PRE-BID ADDENDUM No. 001
for
LITTLEFIELD TOWNSHIP
HAY LAKE MARINA PARK
MARINA AND SITE IMPROVEMENTS

Date of Issue: Monday – November 13, 2018

EXISTING CONDITIONS & REMOVALS PLAN
HAY LAKE MARINA PARK
LITTLEFIELD TWP, EMMET CO., MI

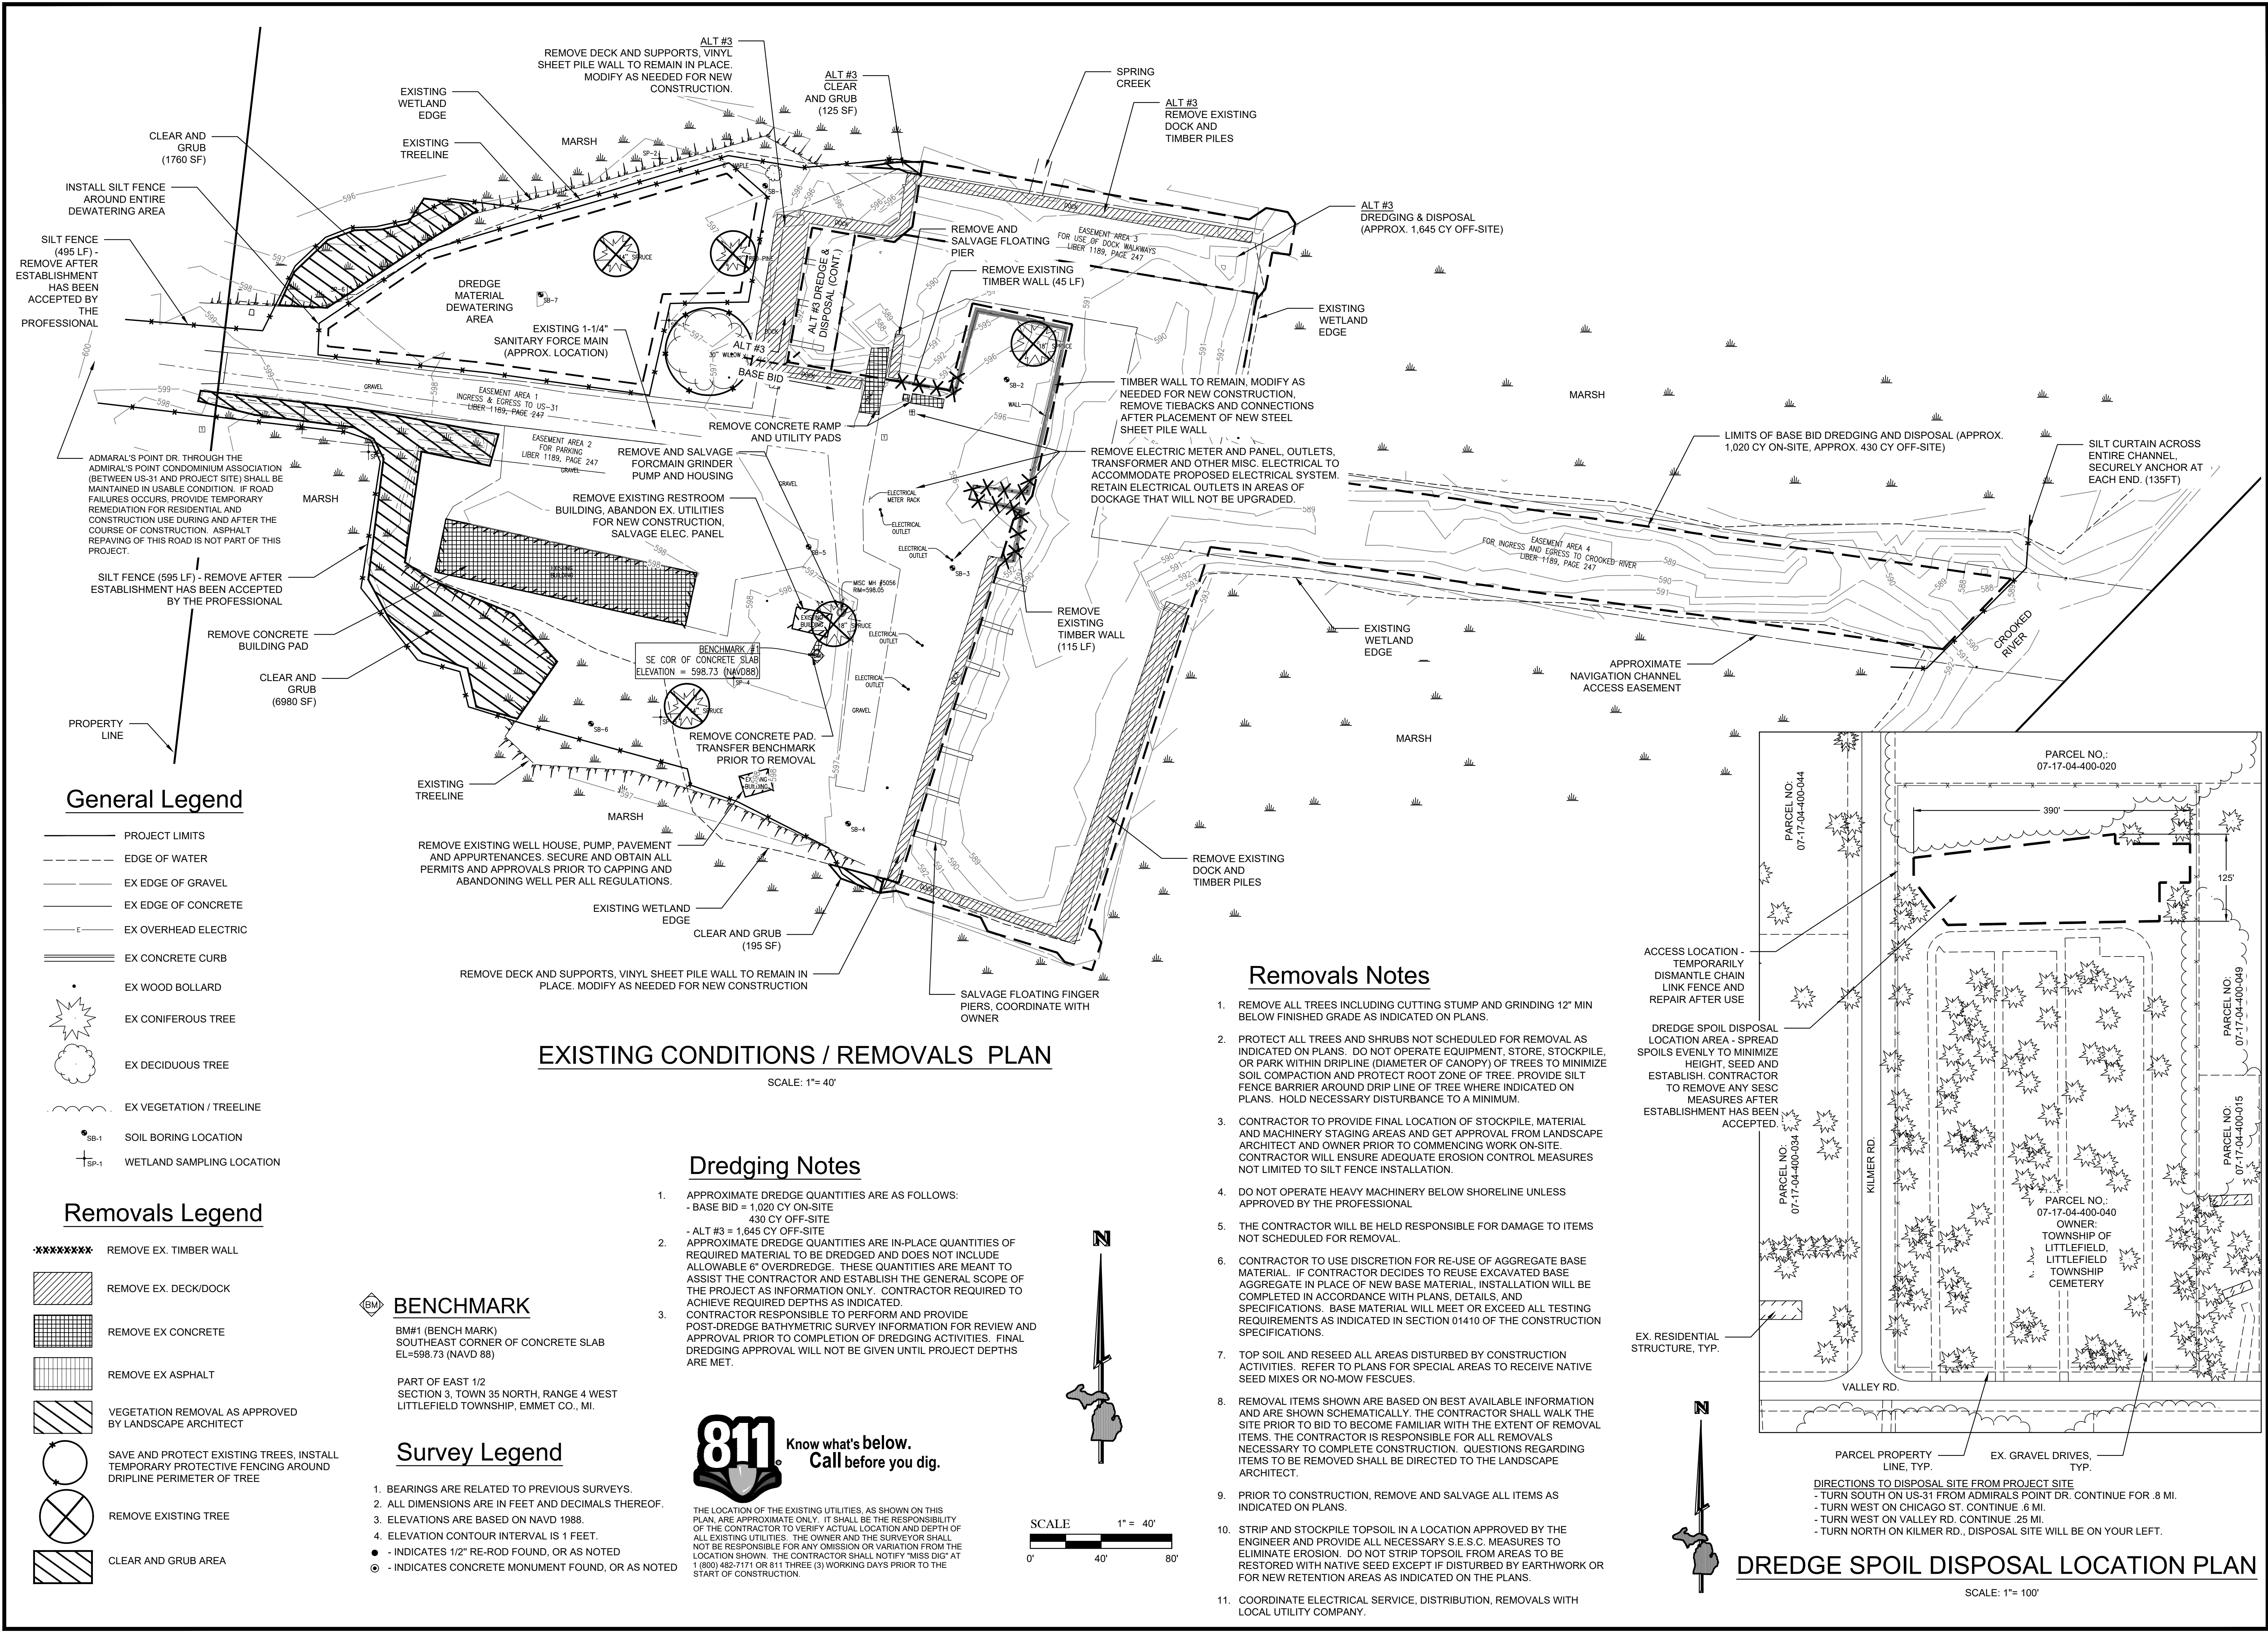
SHEET S1: See updated sheet with additional existing site grade information and upland contour grades.

SHEET PILE WALL DETAILS
HAY LAKE MARINA PARK
LITTLEFIELD TWP, EMMET CO., MI

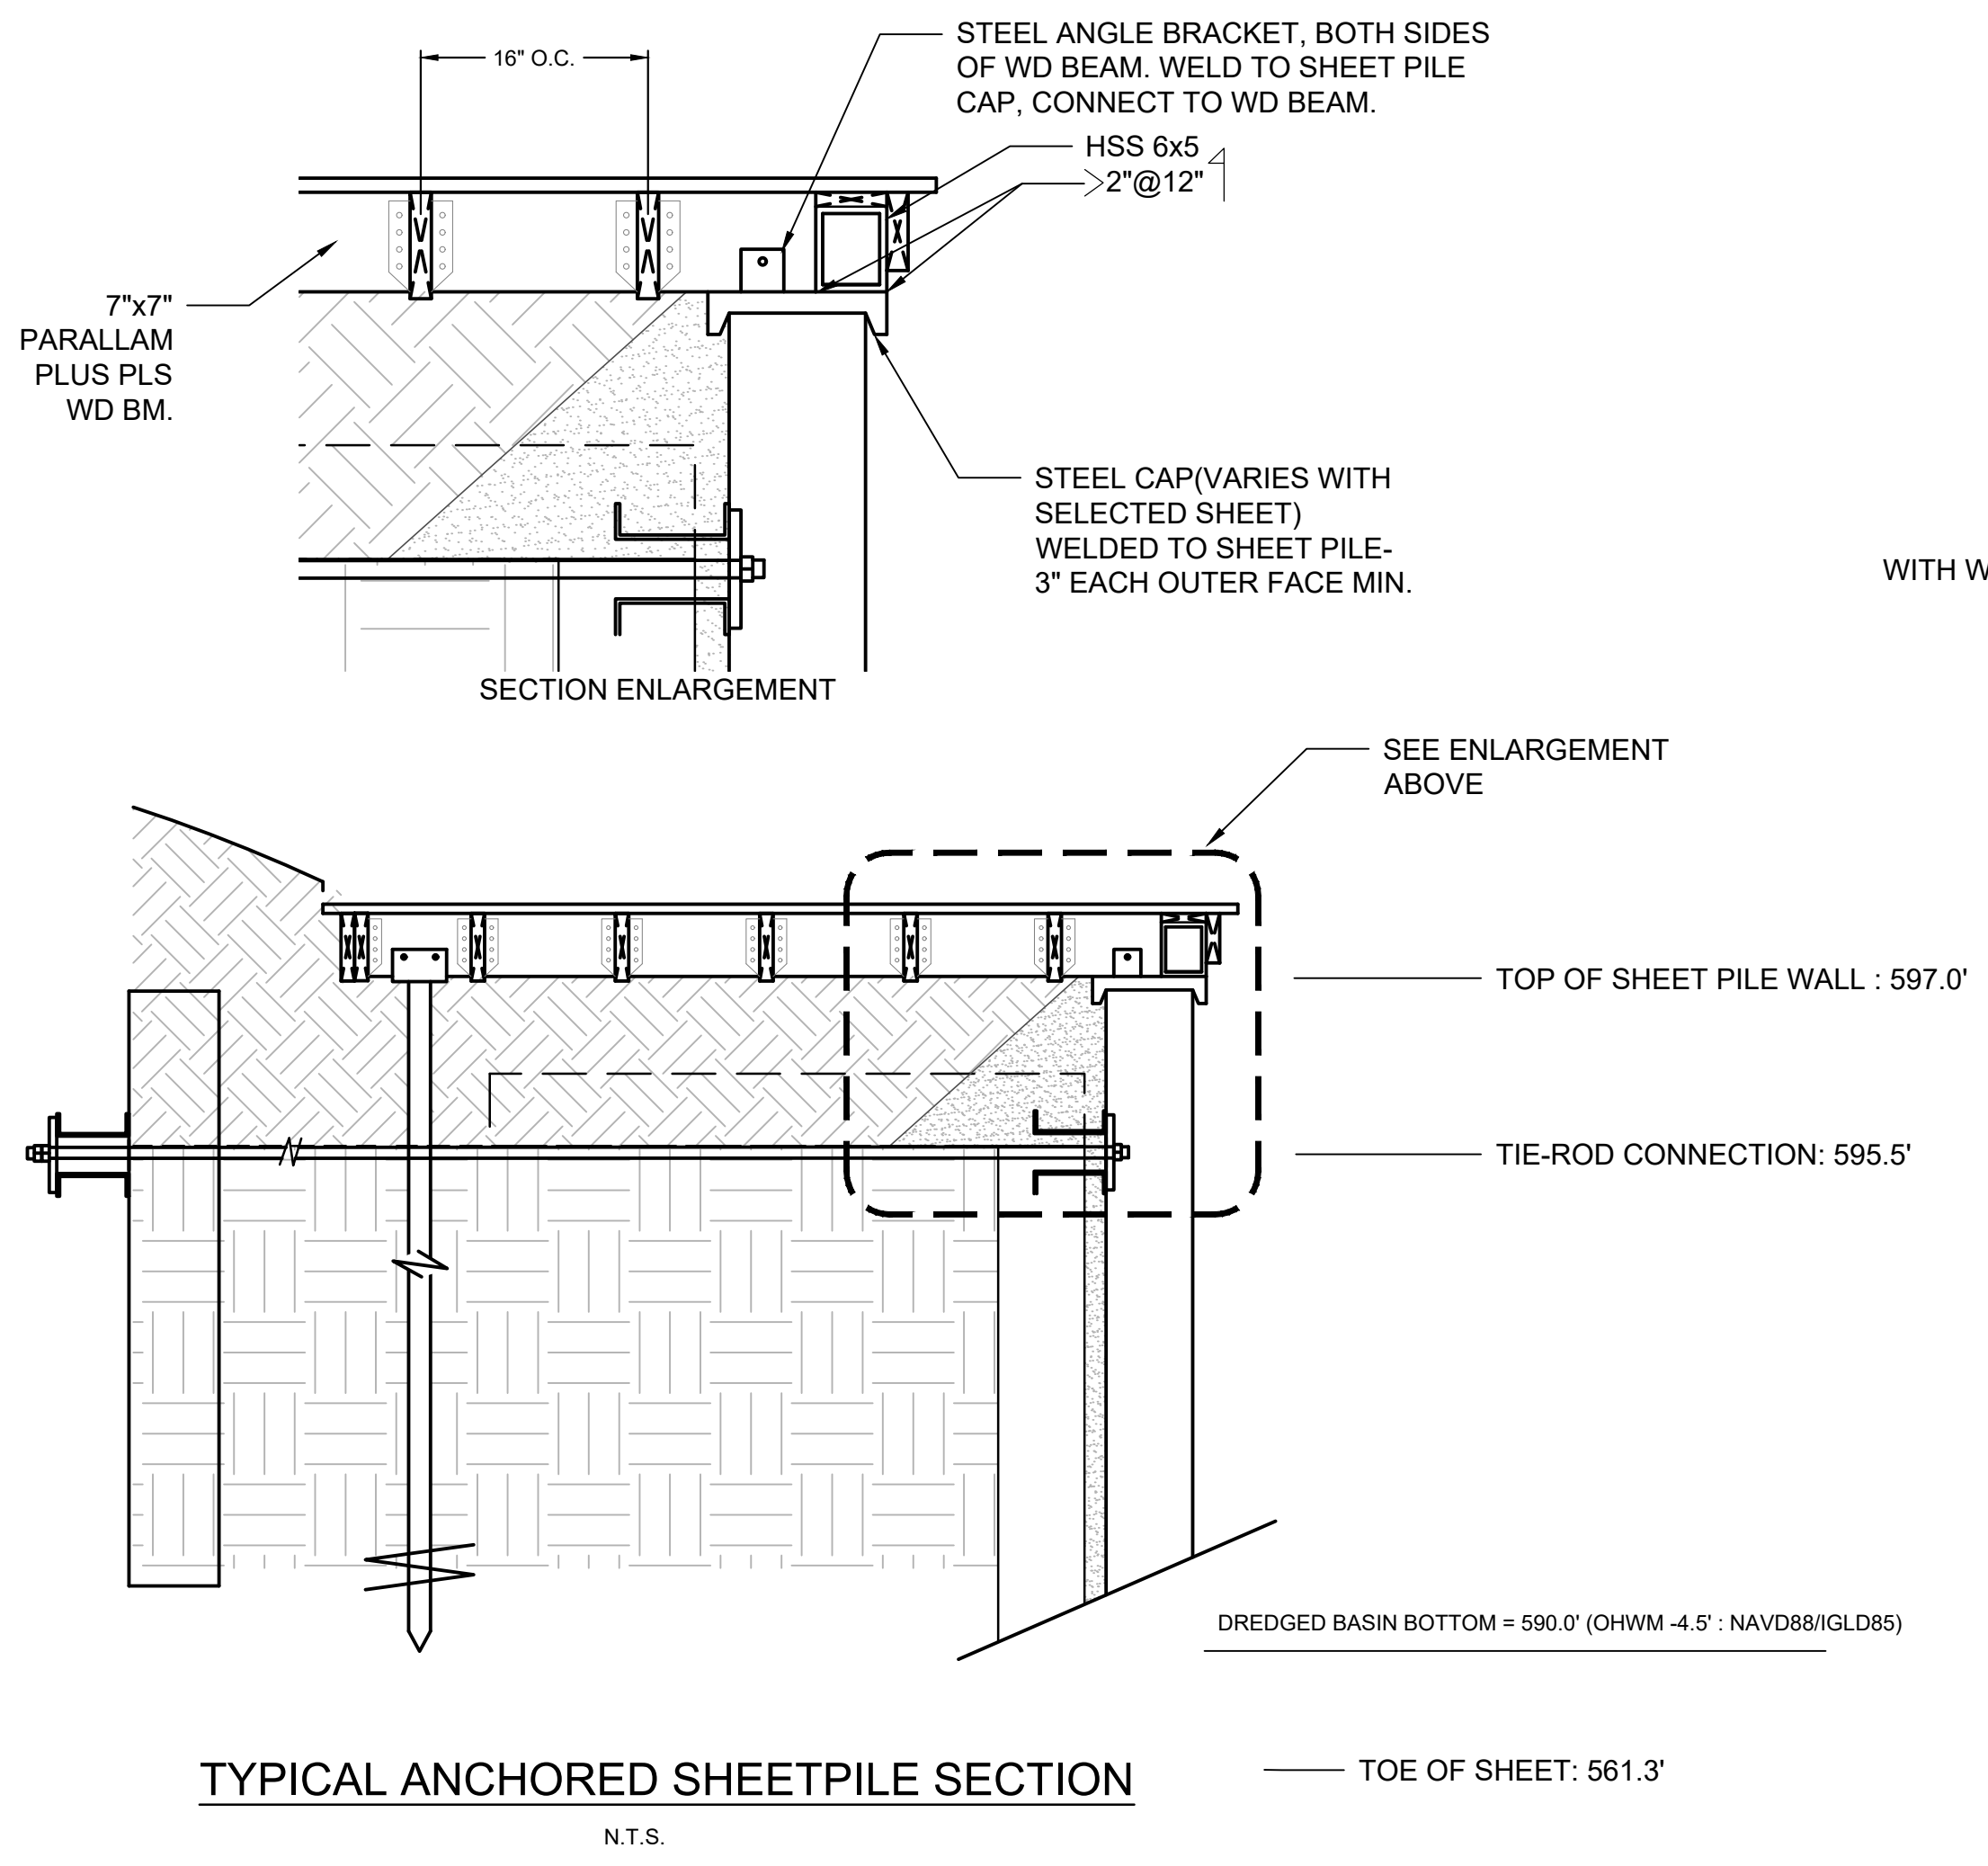
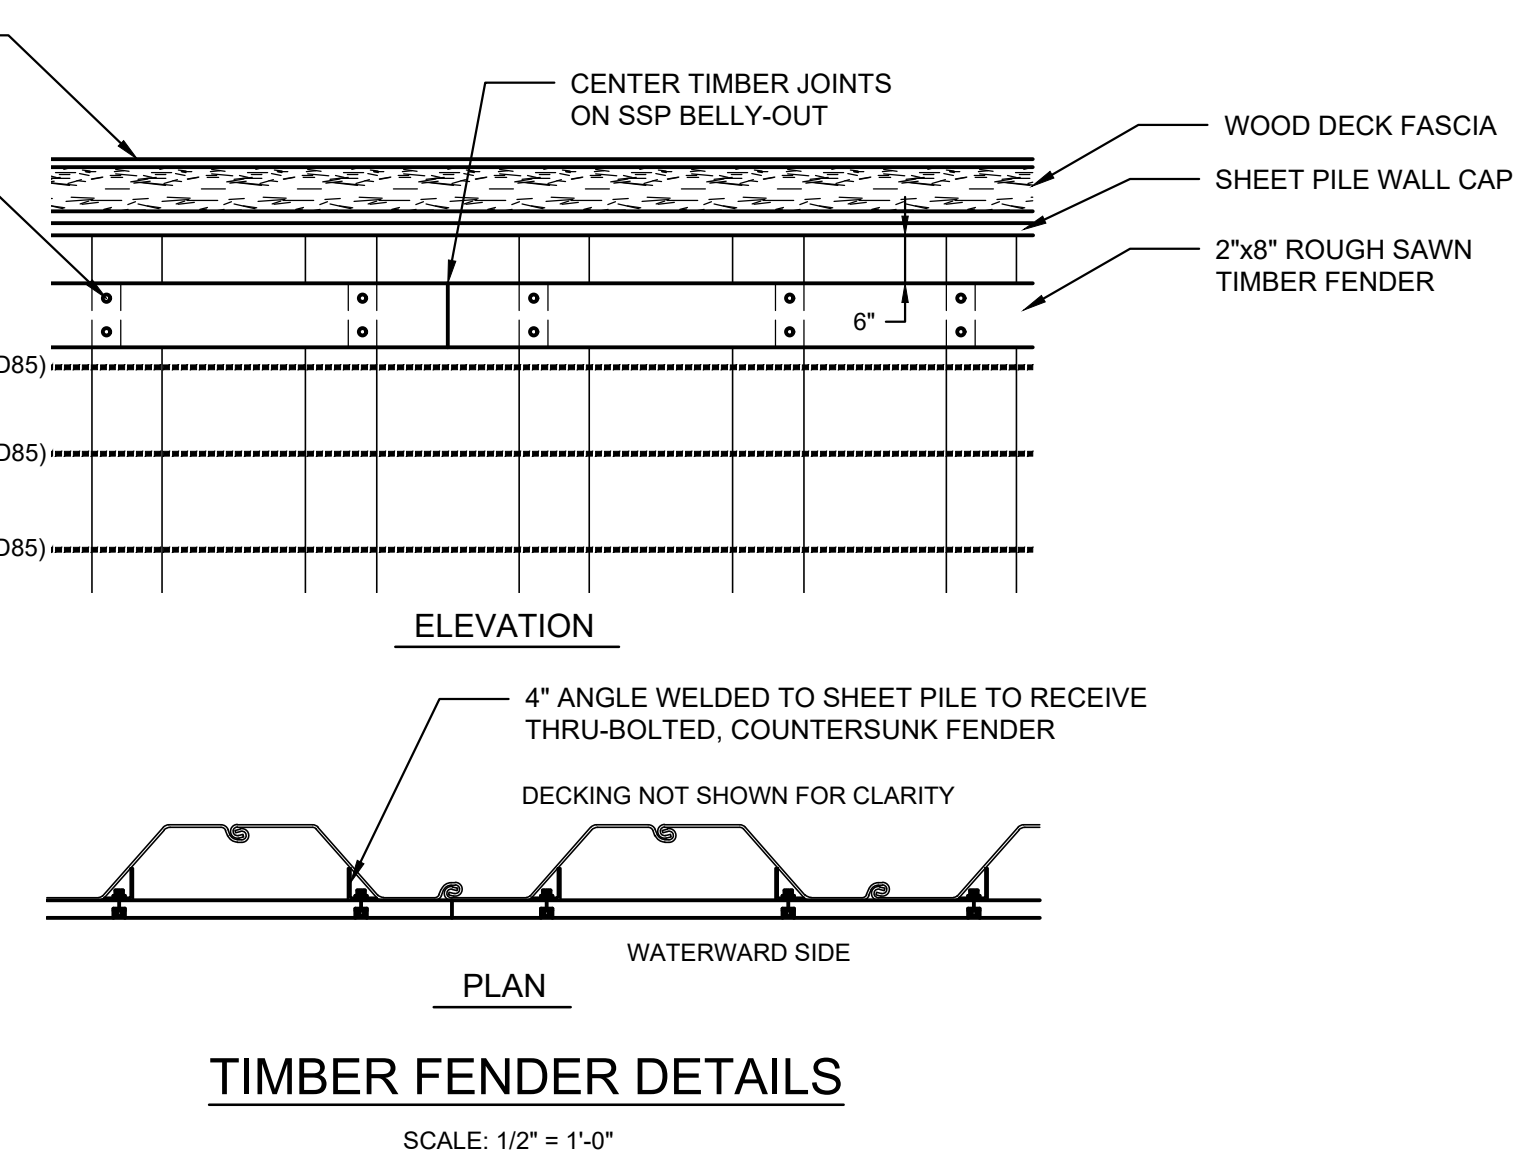
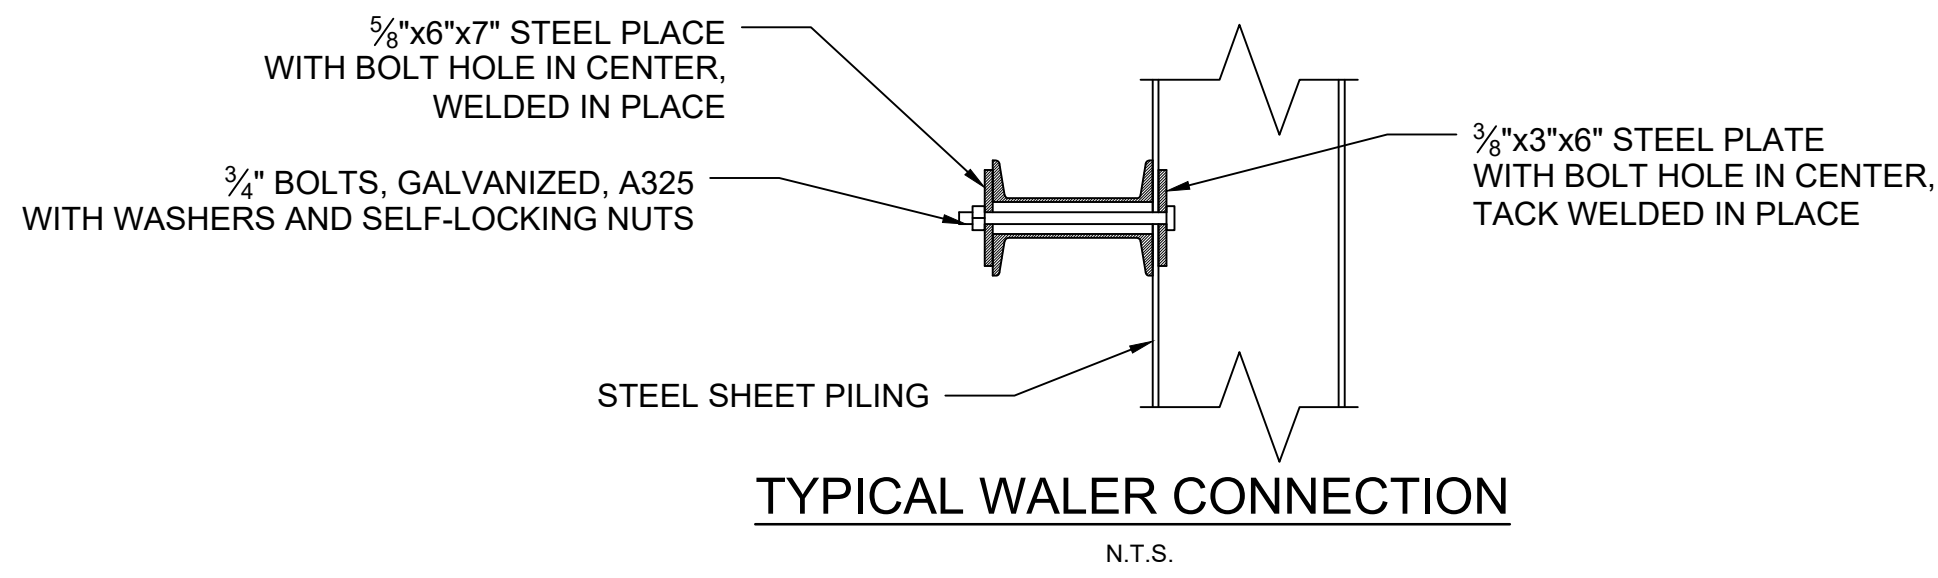
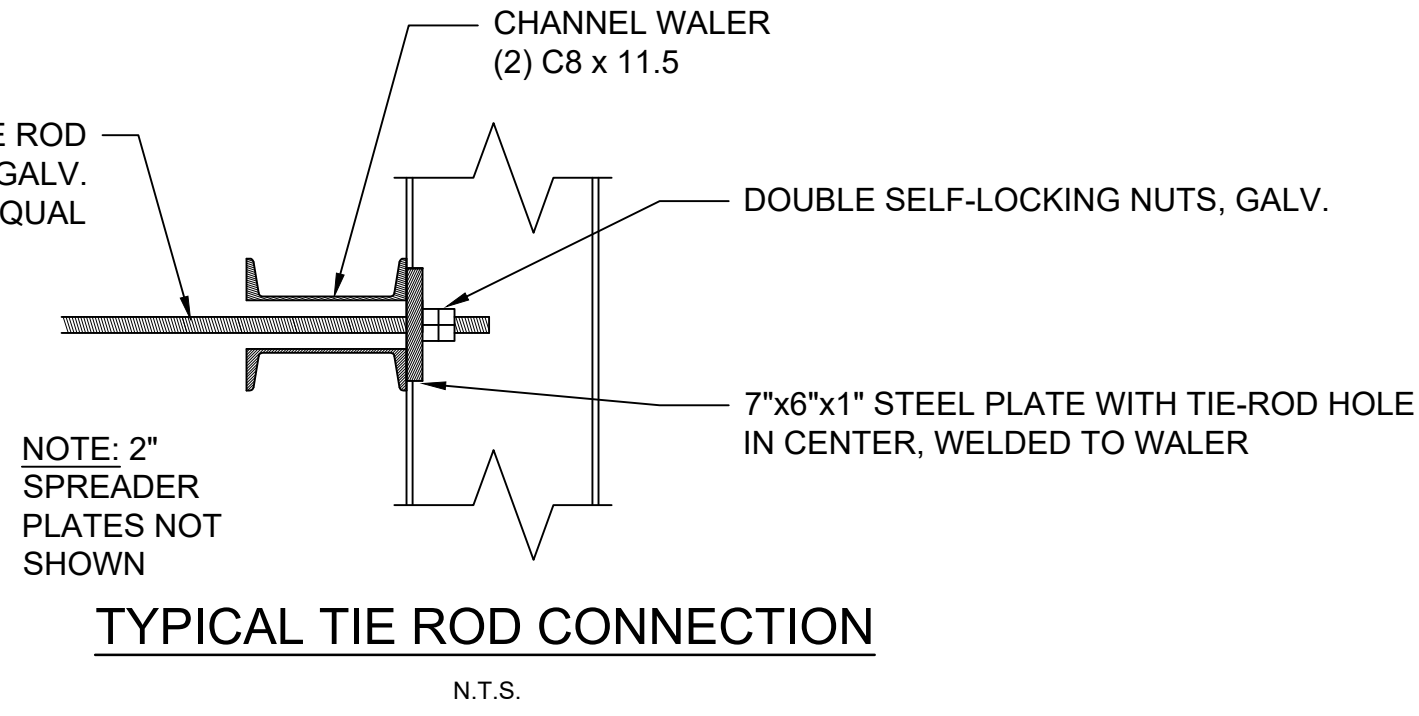
SHEET S9: See updated fire intake detail with new call out for 6" NH female connection and 6" HDPE intake pipe.

Q: Is it correct that galvanized bolts should be used for sheet pile tieback and rod connections, and zinc or cadmium for sheet pile waler connection (details sheet S9)

Q: Are the sheet pile system waler spacers on top of or between the two c-channels?

A: Yes

A: Between
